**CITY OF MIAMI BEACH**  
**Office of the City Manager**  
**Letter to Commission No. 229-2004**

**Subject:** **REHABILITATION OF THE 63RD STREET BRIDGE, CONSTRUCTION OF  
AT-GRADE INTERSECTION AT 63RD STREET AND INDIAN CREEK  
DRIVE, AND RECONSTRUCTION OF INDIAN CREEK DRIVE FROM 63RD  
STREET TO ABBOTT AVENUE**

Re: FM No. 249940-1 / 407935-1 / Replacement of 63<sup>rd</sup> Street Flyover and  
63<sup>rd</sup> Street Bascule Bridge rehabilitation

**N.W. 63<sup>rd</sup> Street Bascule Bridge**

**FLOOR BEAM 1**

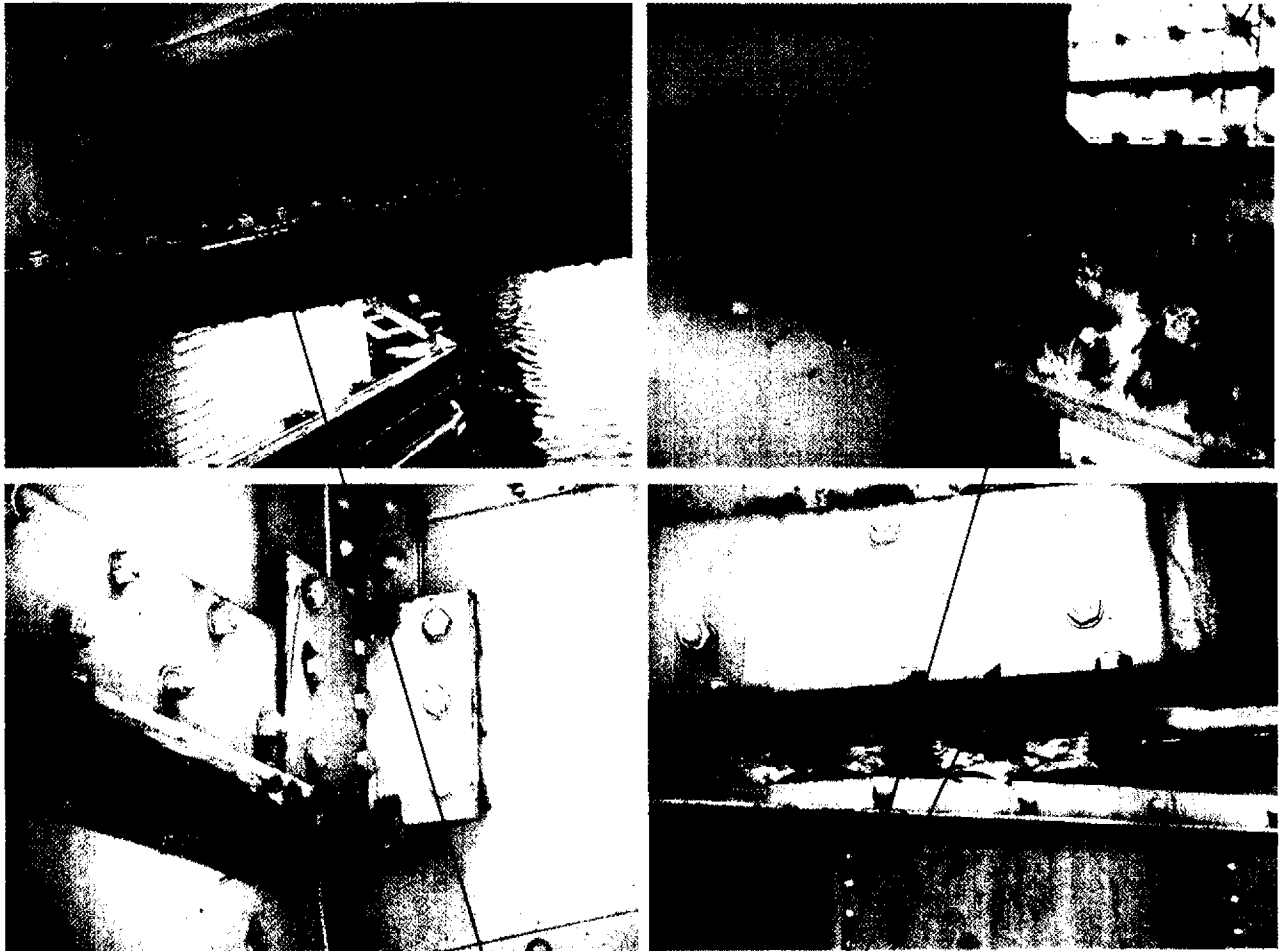
**Critical Member due to Load Rating**

Member requires that the bridge be posted at operating level for almost all Florida legal trucks. Truck loads will be reduced from 10% to 30% of legal weights, even without consideration of loss of section.

In most cases this member is in good condition, except at ends where lateral bracing connections are made.

Post bridge to reduce truck loading or take bridge out of service and replace beams in all 4 locations. Strengthening of this member is not viable due to the added weight and the need to balance bridge.

**FLOOR BEAM 2**

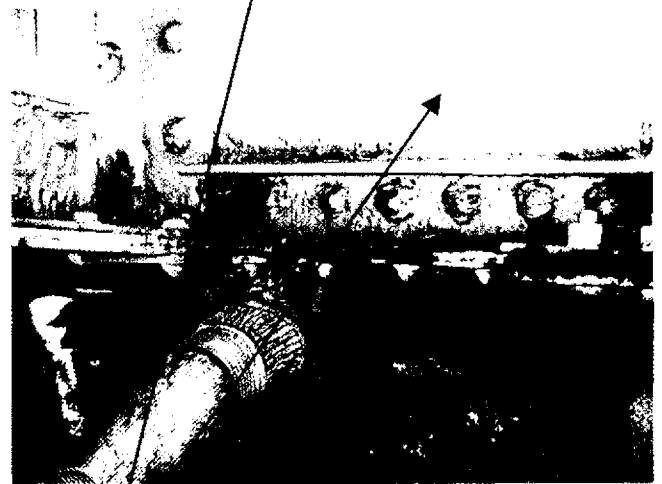
Member was cover plated in 1988 to repair badly corroded top and bottom flanges. Cover plates have also become badly corroded.

Take bridge out of service and replace beams in all 4 locations or take bridge out of service and replace all cover plates in all 4 locations to strengthen.

### **TRUNNION GIRDERS**

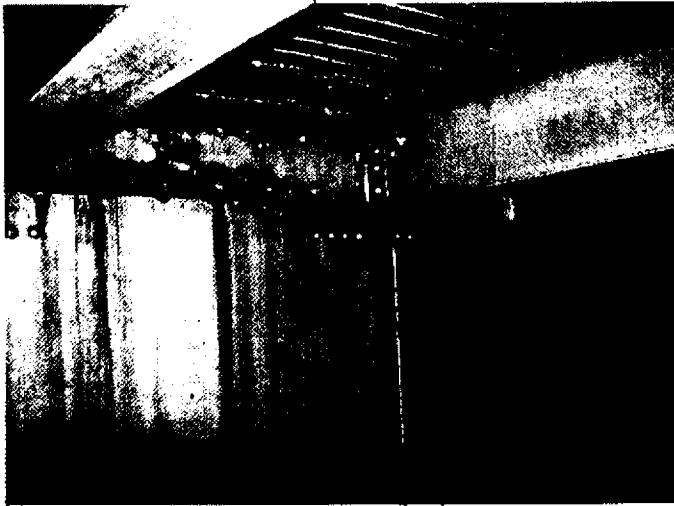
The top flanges of these girders are corroded. They support the concrete filled grating, which as noted above is recommended to be replaced.

Remove and replace top flange of trunnion girders

## Machinery

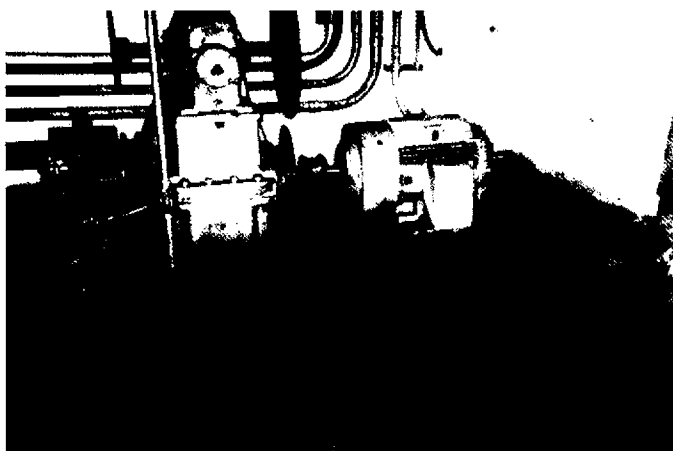
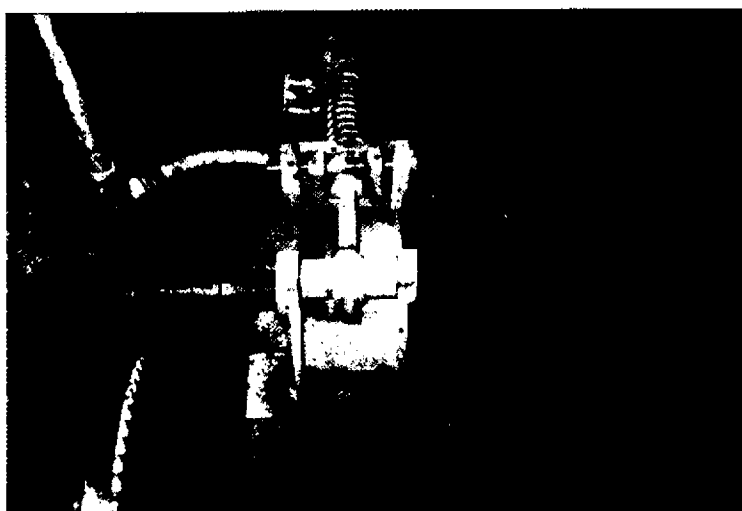
The span drive machinery was heavily corroded, heavily worn, and lacks a means of load sharing between the rack pinions. The rack teeth engaged with the leaves seated were deformed from restraining the leaves from bouncing under live load.

One of the enclosed reducers had heavy internal corrosion with rust particles contaminating the lubrication and potential bearing failure. Many bearings were inaccessible for clearance measurements due to the machinery configuration. Those bearings measured showed moderate to heavy wear.

The recently installed 20 HP motors are twice as powerful as the original 10 HP motors and subject the machinery to potential overstress. AASHTO operating horsepower requirement calculations justify the need for 20 HP motors, but the existing machinery was designed for 10 HP motors.

Each leaf originally had a motor and a machinery brake. The motor brakes were removed from each leaf when the 20 HP motors were installed. The remaining machinery brakes were in poor condition and may not stop or hold the leaves in an emergency stop or high wind condition.

The leaves bounced excessively under live load due to excessive span lock clearance, improper seating of the leaves on the live load shoes, and the removal of the tail locks. The connection between the end floor beam and span lock support beam was loose at the extreme north span lock.

Take bridge out of service and replace all of the existing machinery. The system should provided a means of load sharing. Provide new span lock and tail locks.
